IEEE P802.3ba  
New ICR fitted line methodology required

**Vittal Balasubramanian**  
**Sr. Signal Integrity Engineer**  
**FCI USA, Inc.**  
**7-Jan-2009**

# TwinMezz – Long Link – Pair 2

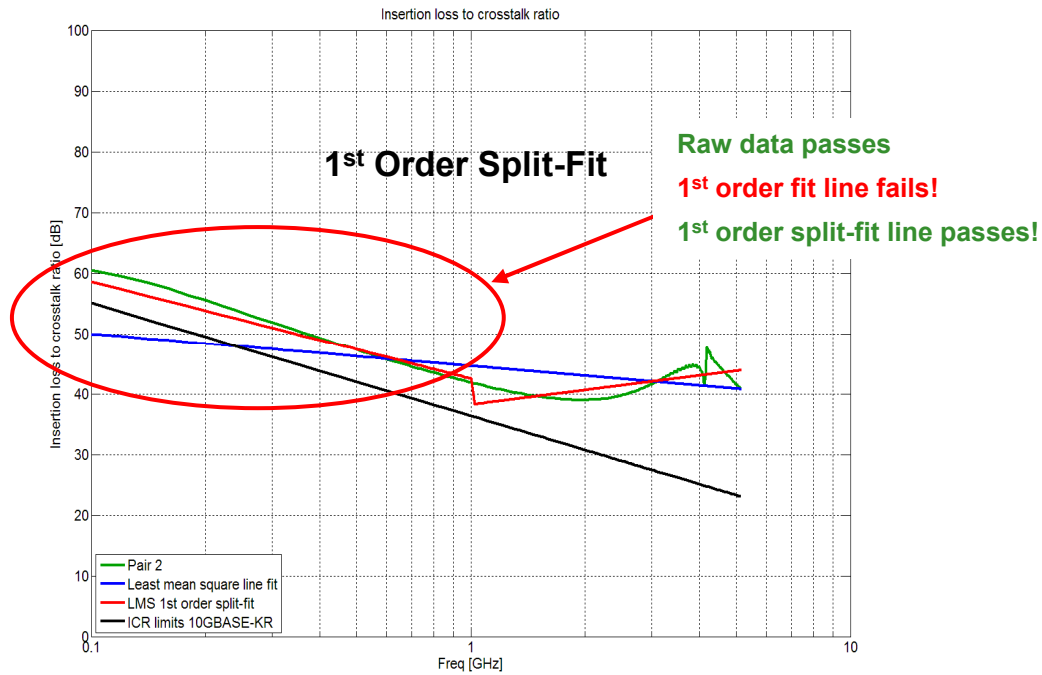
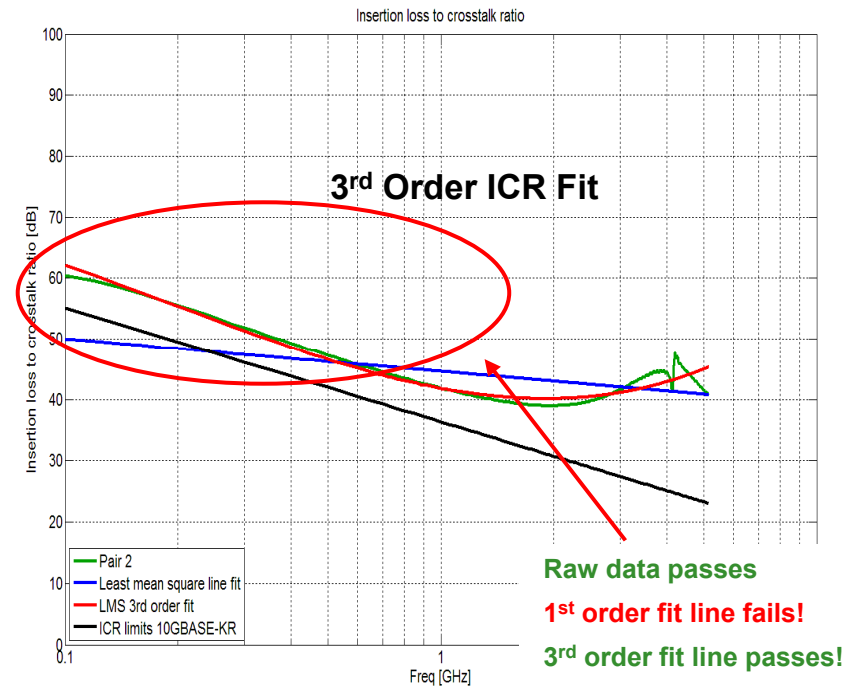
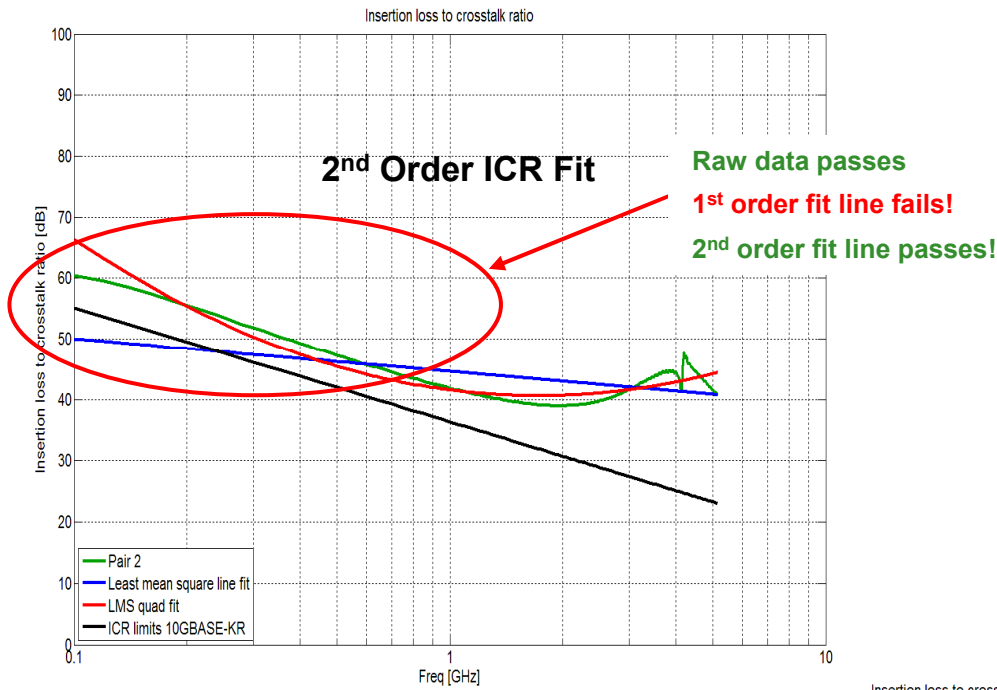
- Current linear least-mean-squares fit curve does not correctly fit all cases
- Possible Options
  - 2<sup>nd</sup> order least-mean-squares fit curve improves some but has errors in other cases
    - Not desirable
  - 3<sup>rd</sup> order least-mean-squares fit curve is accurate, but mathematically very involving
    - Not desirable
  - Propose changing the ICR fit line to a two-segment linear least-mean-squares fit
    - Best solution
- Change needs to be made to both backplane and copper cable assembly ICR fit equations

- Use current ICR equations – with two distinct linear segments for different frequency ranges
  - $y = a + b \log x$ 
    - where  $y = \text{ICR}(\text{fit})$  and  $x = \text{frequency}$
  - Frequency ranges
    - $100 \text{ MHz} \leq f \leq 1 \text{ GHz}$
    - $1 \text{ GHz} < f \leq 5.15625 \text{ GHz}$
- This requires the following changes
  - Eqn. 69B-15 changes to:
    - $PSNEXT_1(f) = -10\log\left(\sum 10^{-NEXT_n(f)/10}\right)$  for  $100 \text{ MHz} \leq f \leq 1 \text{ GHz}$
    - $PSNEXT_2(f) = -10\log\left(\sum 10^{-NEXT_n(f)/10}\right)$  for  $1 \text{ GHz} < f \leq 5.15625 \text{ GHz}$
  - Eqns. 69B-16 through 69B-24 are changed similarly to accommodate for two linear segments
